Vermeer MV Solutions, Inc.

FIELD CAMPAIGN KIT #: VMV000083 **DATE:** 23 May 2024
For Dealer Reference: Service Bulletin #: SMV2024-013

Remote Control Decal Update Kit (Optional Rocket Remote Control Only)

Purpose: Buttons on remote control may remain actuated

Figure 4 Updated decal with Vermeer logo

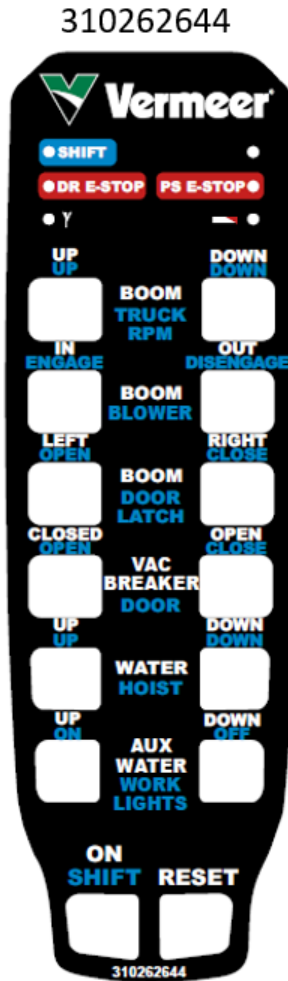
The buttons on the remote control may be held in the depressed position due to assembly and small button opening size. If a button or buttons remain in the depressed position, the associated function(s) will continue to be activated. If this failure occurs prior to installation of the kit, **turn off truck’s engine with key to stop movement.** This update will remove the existing control decal and replace it with a new control decal with larger button openings.

VMV000083 has been created to provide the necessary parts and instructions to install an updated decal onto the remote. **The kit must be installed as soon as possible.**

Note: All remotes will be replaced without a screen cutout, including if a cutout was on the original decal.

5. Verify that no button sticks or catches under the decal when pressed,

Figure 4 Parts List			
<u>REF. NO.</u>	<u>PART NO.</u>	<u>DESCRIPTION</u>	<u>IK01 QTY.</u>
1	310262644	DECAL-VXT ROCKET RMT NO SCREEN	1
		Kit includes all items in Figure 4 parts list.
